R78 – 2023

**Historical Architectural Review Board
COA Final Review Sheet**

HDC-2023-00014

Proposal: Reconstruct front porch

**Drawing of porch reconstruction.
(Applicant)**

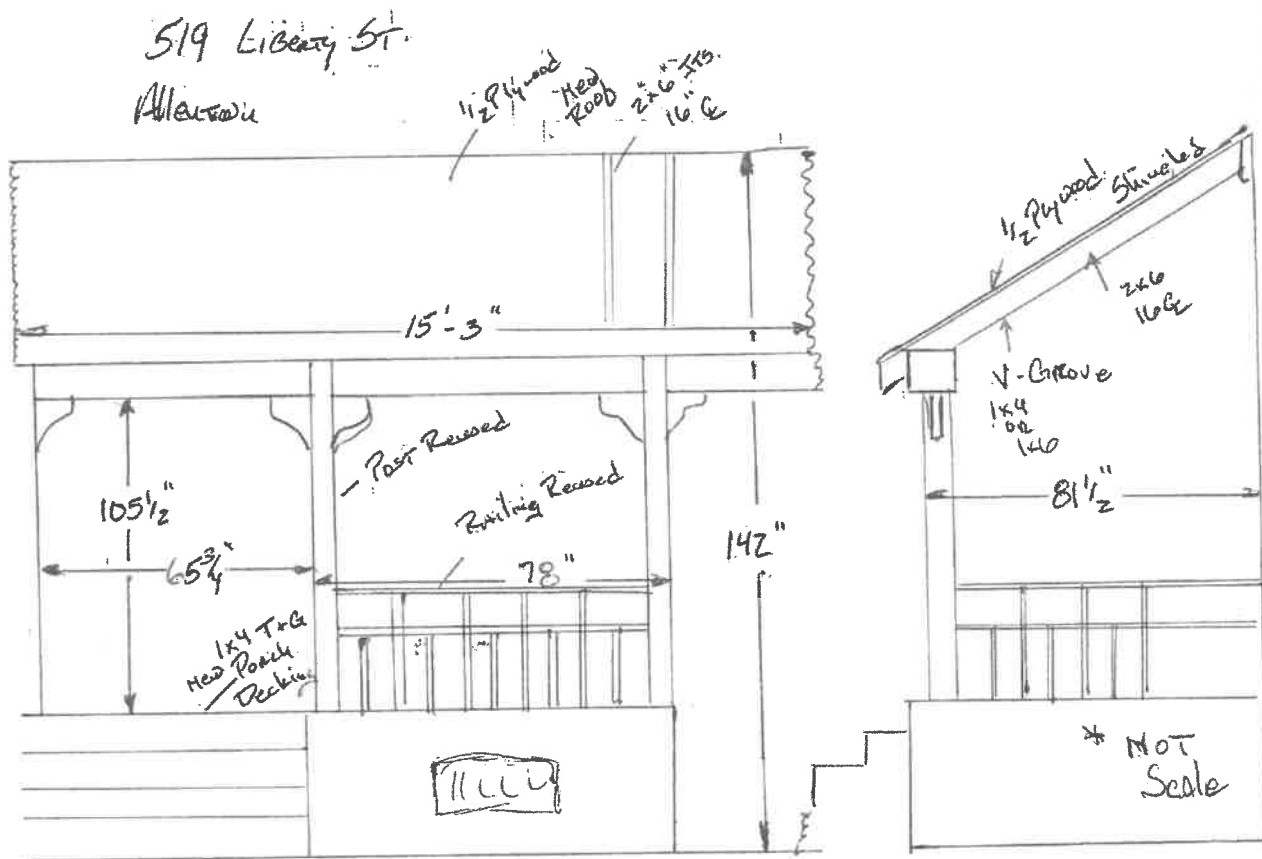
The applicant contends that the porch roof is in poor condition and requires replacement, and the floorboards show visible signs of warping, displacement, and deterioration. The design guidelines recommend replacing features with new materials matching in composition, size, shape, profile, dimension, appearance, and finish. The application proposes to rebuild the roof to the same appearance and replace the decking with new tongue and groove floorboards. Because the applicant also proposes to salvage and reinstall the historic posts, brackets, and railings, the application complies with most guidelines in Chapter 3, Section 3.7 Porches & Steps. In order to better comply with the guidelines, staff recommends using a roofing shingle that more closely replicates the dimension, size, shape, and color of the historic slate roofs of the row; however, staff notes that no porch roof retains the original slate, so some flexibility should be granted. Staff also recommends avoiding wrapping the header fascia with aluminum, which would not comply with the guidelines. While the proposed vinyl vented ceiling does not comply with the material recommendations of the guidelines, staff contends that if the material is installed behind the porch header, it will have minimal visibility from the street and may be considered, since it will have low overall impact on the façade.

- the asphalt shingles on the new porch roof match the general dimension, size, shape, and color of the historic slate roofs of the row;
 - the proposed vinyl ceiling is limited to the area behind the porch header and is minimally visible from the street; and
 - the fascia is not wrapped in aluminum.
-

Mr. Overdorf explained that the porch structure is entirely rotted and needs to be removed and rebuilt. He clarified that he could use beadboard at the ceiling of the roof where he initially proposed the vinyl soffit, though he noted the owner requested vinyl for maintenance reasons. The existing porch posts and railings, he continued, would be scraped and painted, and he would install tongue-and-groove wood flooring. He noted the flooring would be a close, but not exact, match.

Mr. Huber asked whether the applicant would install beaded tongue-and-groove wood at the ceiling. Mr. Overdorf affirmed he would use the wood tongue-and-groove beadboard, which would be installed over the rafters. The HARB and applicant discussed the finishing of the rafter tails and the dimension of the overhang, which would be replicated.

Mr. Jordan asked about the roof shingles. Mr. Overdorf responded that he could use 3-tab shingles rather than architectural shingles to better replicate the shape and dimension of slate. He added that the gutters would be replaced. Mr. Huber requested half-round gutters, and Mr. Overdorf agreed.

Mr. Jordan moved to approve with conditions the application presented on 4/3/2023 for the reconstruction of the porch at 519 W. Liberty Street, as agreed to by the applicant and with the staff to review details, pursuant to Chapter 3, Section 3.7 Porches & Steps, provided the following:

- the fascia is wood;

- the ceiling is wood beadboard rather than vinyl;
- half-round gutters are installed; and
- the asphalt shingles on the new porch roof match the general dimension, size, shape, and color of the historic slate roofs of the row.
